DEVELOPMENT REVIEW BOARD
SUPPLEMENTAL SUBMITTAL

PROJECT NO. PR-2022-006497

Application No. SI-2022-00124

To: City of Albuquerque Development Review Board
From: Michael Vos, AICP, Consensus Planning, Inc. 
Date: March 4, 2022
Re: PR-2022-006497 Sunport Hotel DRB Comment Responses

A1.1

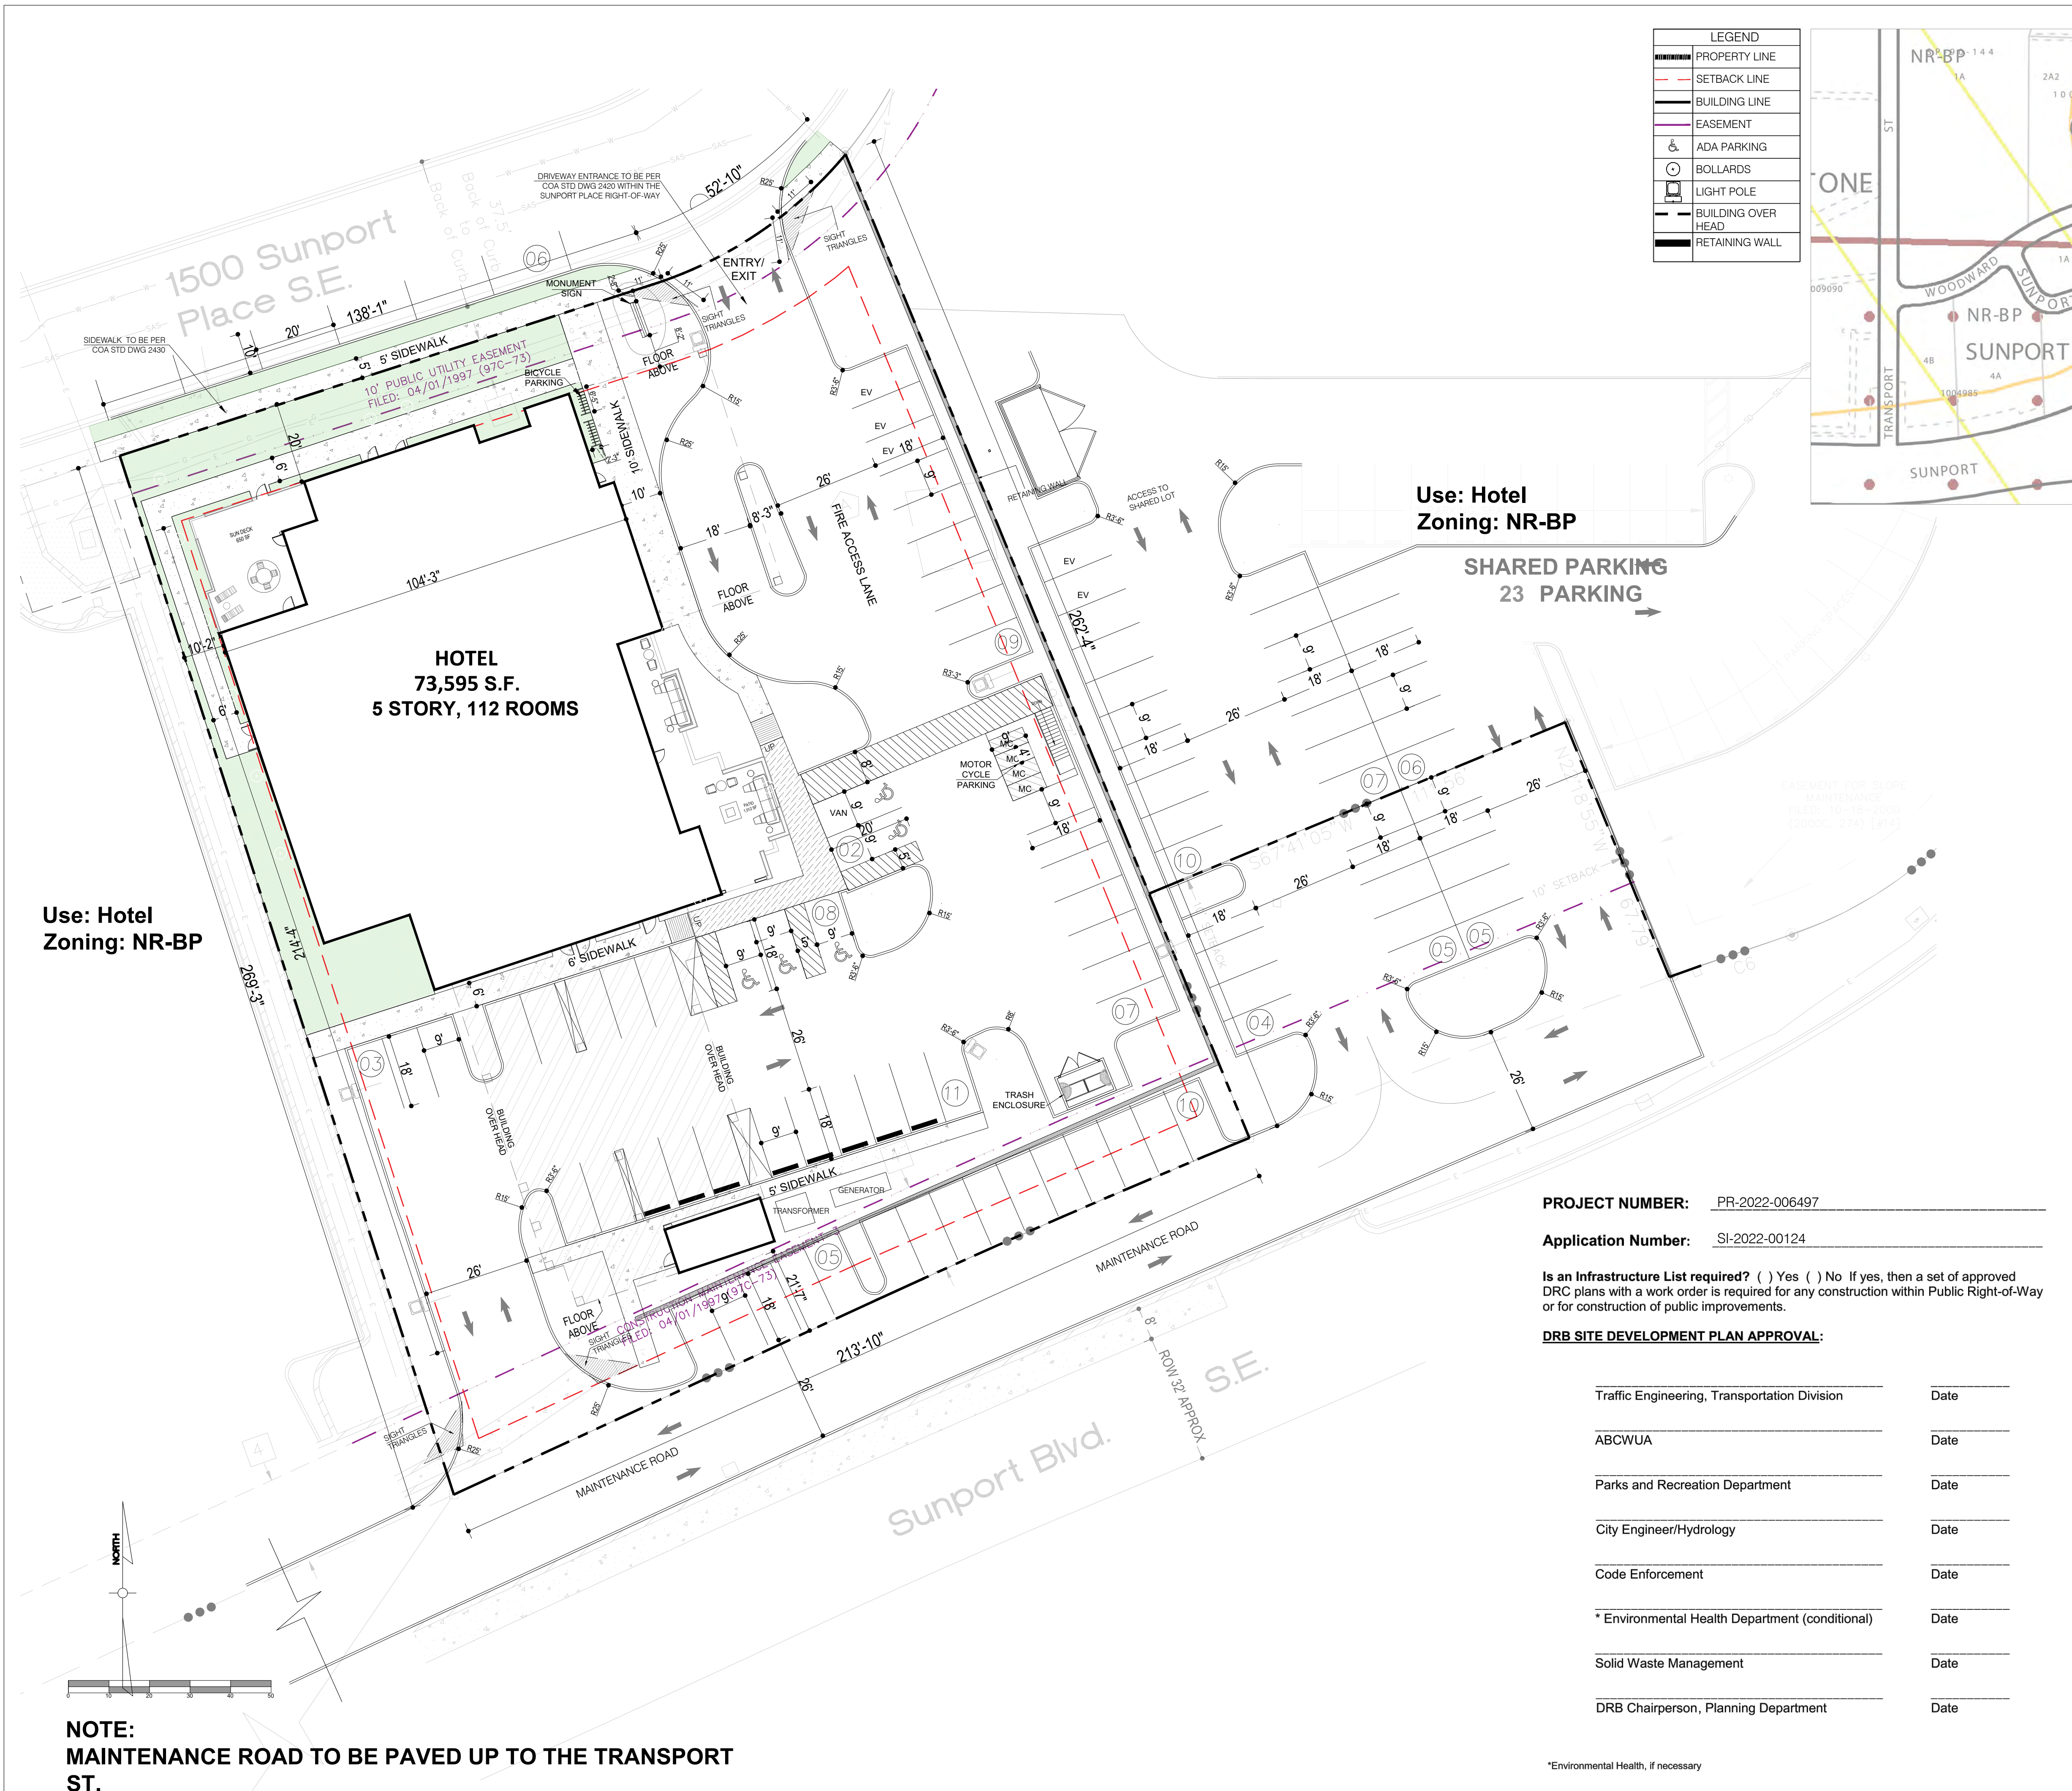
7. Access and Connectivity – On-Site Pedestrian Connections: IDO 14-16-5-3(D)(3)(b)(4) and Table 5-3-1 requires that “walkways shall be installed on any street-facing façade with a pedestrian entrance of a building.” Table 5-3-1 requires buildings of this envelope size to have a minimum walkway width of 10 feet along this façade. Please modify the plan along Sunport Place to meet requirements or seek a Variance to required width. Other DPM standards may apply, as well.

12. Monument Sign – clarify proposed square footage of signage area – appears larger than noted. Also mark distance from property line to monument sign.
 - *Sign calculations have been updated and a dimension has been added to the site plan.*
13. Wall Signs – show size of sign area and percentage of façade for each proposed wall signage location.
 - Dimensions and sizes have been added for the wall sign locations.

3. Implement clear sight triangles using intersection sight distance at each of the drives. Show these on both the site plan and landscaping plan.
 - *Clear sight triangles have been added.*

8. Call out all signage (handicapped signage and motorcycle parking signage) and curb ramps on the site plan. Also, graphically show the curb ramps on the site plan. Use keyed notes to reference details on the detail sheet.

- *The Applicant has expanded the walkway from the public sidewalk to the main entrance, which is located on the east side of the building to 10 feet wide and changed the orientation of the walkway along the northern façade. The IDO defines a Primary Pedestrian Entrance as a publicly accessible entry to the building, which is not the case for the doorways in the center of the northern, street-facing façade, so this walkway was not expanded to 10 feet wide. We believe this condition meets the IDO requirements for minimum walkway width without the need for a waiver due to these conditions.*

- *Curbing and additional dimensions have been added to clarify these limits.*
5. Provide a shared access agreement and parking agreement with adjacent properties.

TYPE 'C' PLAN
CURB ACCESS RAMPS

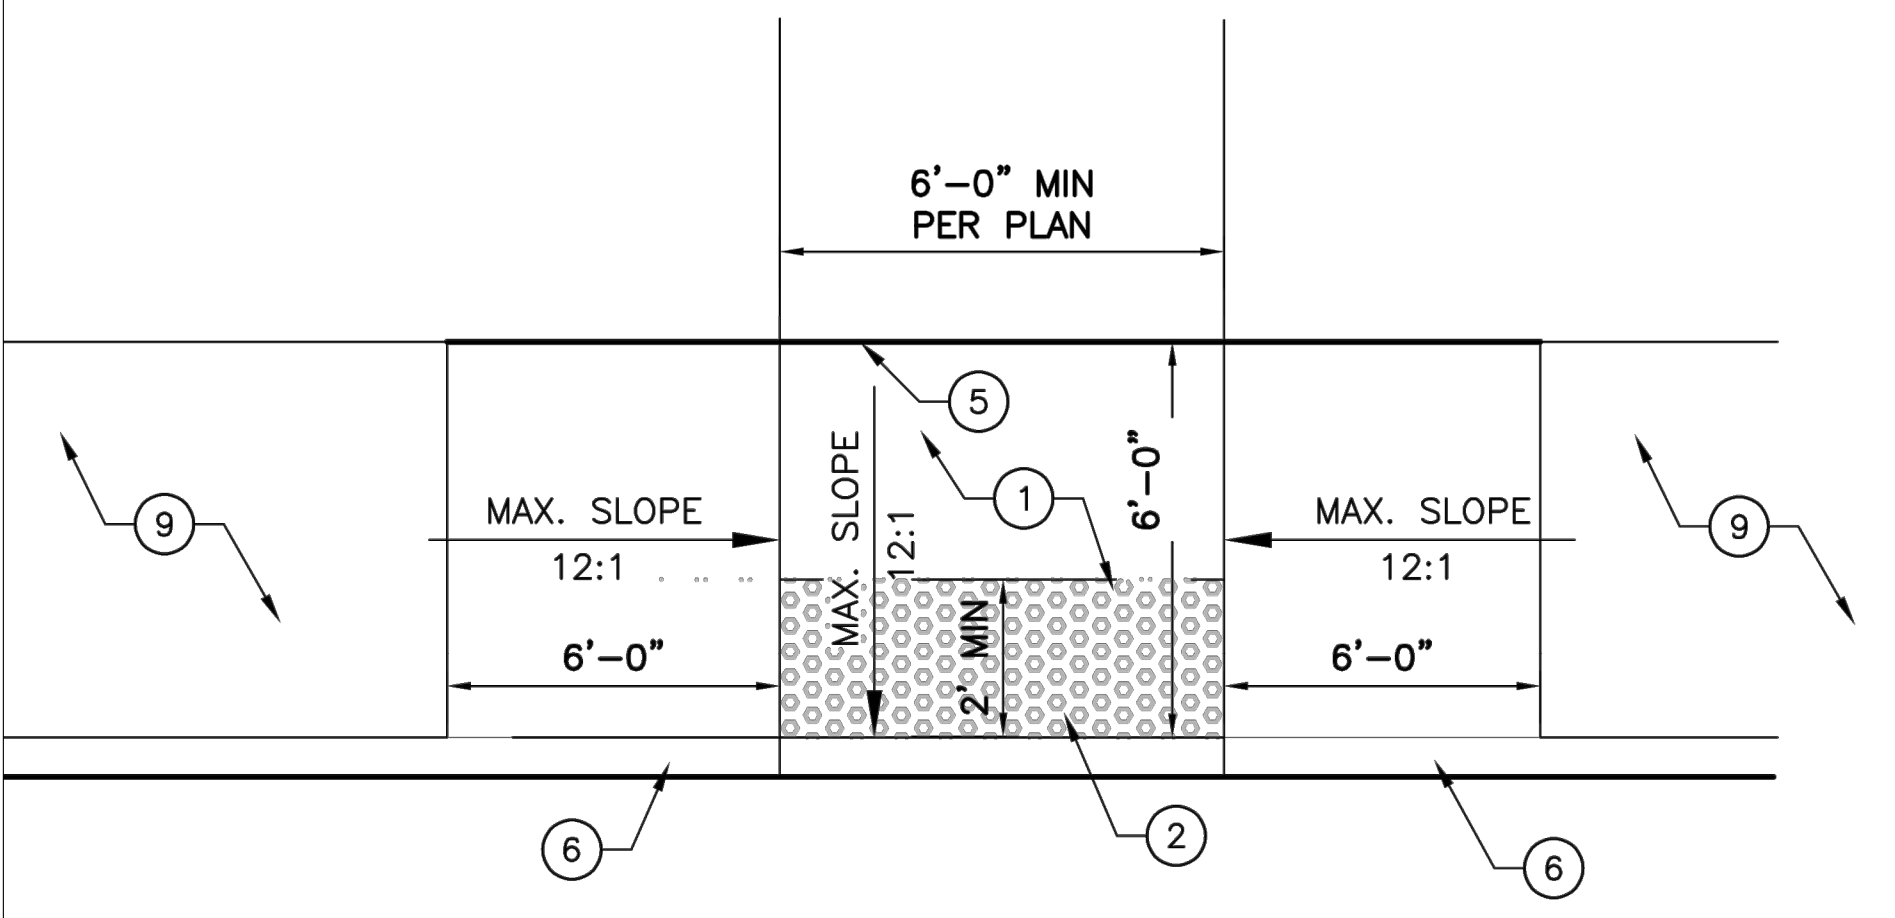
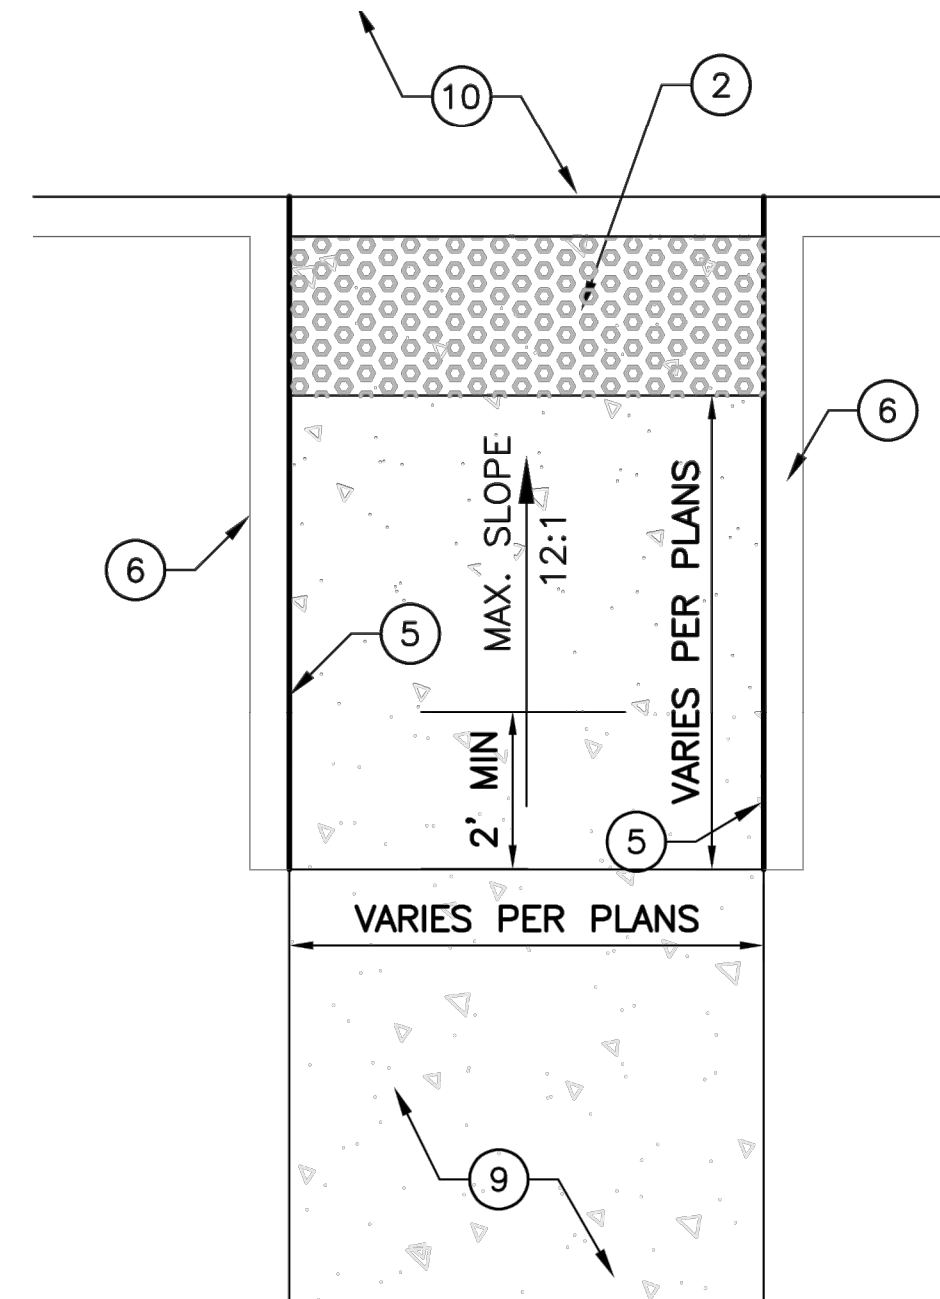
9. Behind the perpendicular curb ramp, call out a minimum 4-foot clear dimension in lieu of 3 feet on the detail sheet.

- *This dimension has been updated.*
10. Dimension overall bike rack location, following DPM requirements. Provide detail for spacing of bike racks.
 - *Additional dimensioning has been added.*
 11. New sidewalk along Sunport Place shall be placed onto an infrastructure list along with the new accessway.
 - *An infrastructure list has been generated by the Civil Engineer and is included in this supplemental submittal.*
 12. Provide one-way signage and “Do Not Enter” signage along with pavement arrows for the one-way drop-off aisle.
 13. Provide width of all sidewalk segments on-site.
 14. Provide a minimum 5-foot dimension for the keyway.
 15. Use standard details to call out all work within COA right-of-way.
 16. Provide all curb radii, following DPM requirements. Dimension all handicapped parking on the site plan.
 - *Additional dimensions, signage, and details have been added.*

LANDSCAPE PLAN

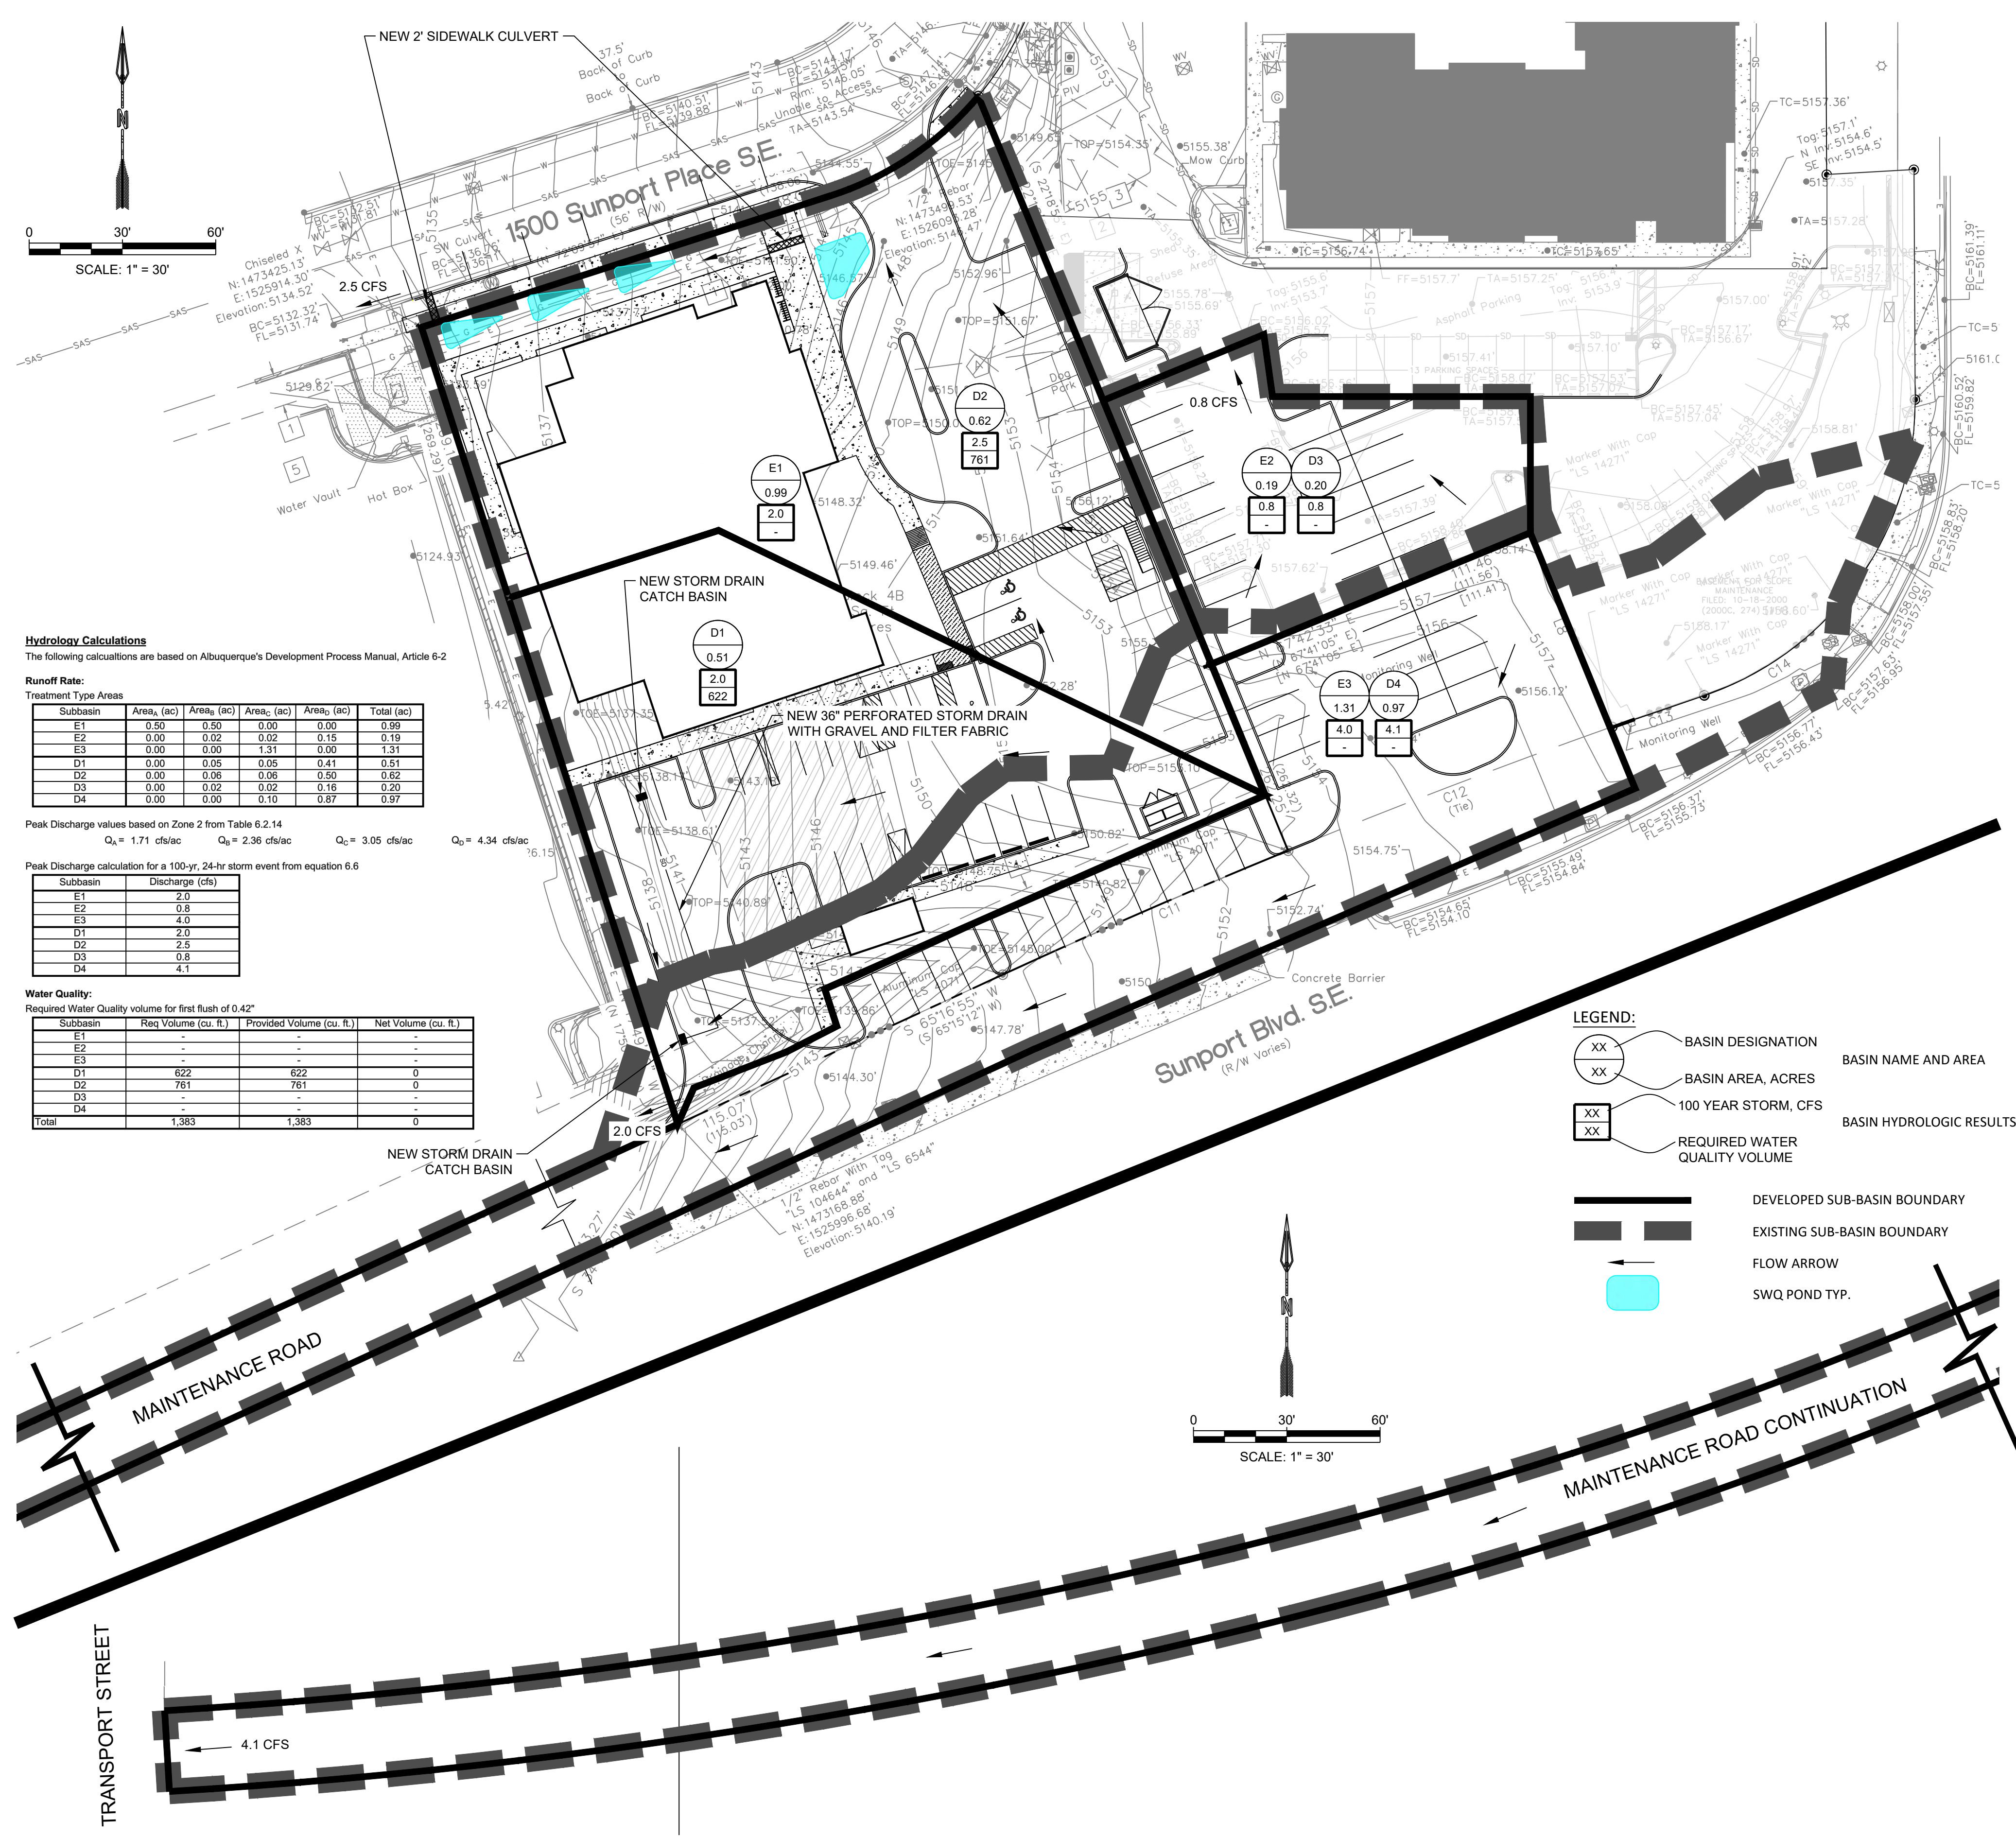
7. The note regarding 'turf' on the Landscape Plan needs to be updated to 'cool season grass species' based on the last IDO update. (See IDO 5-6(C)(4)(d) 'No more than 10 percent of required landscape areas shall be cool season grass species.' See IDO definitions for details on qualifying cool season grasses.)
 - *This note has been updated to reflect current language.*
8. These are preliminary Planning comments, and there could be additional and/or revised Planning comments on this application.
 - *Understood.*
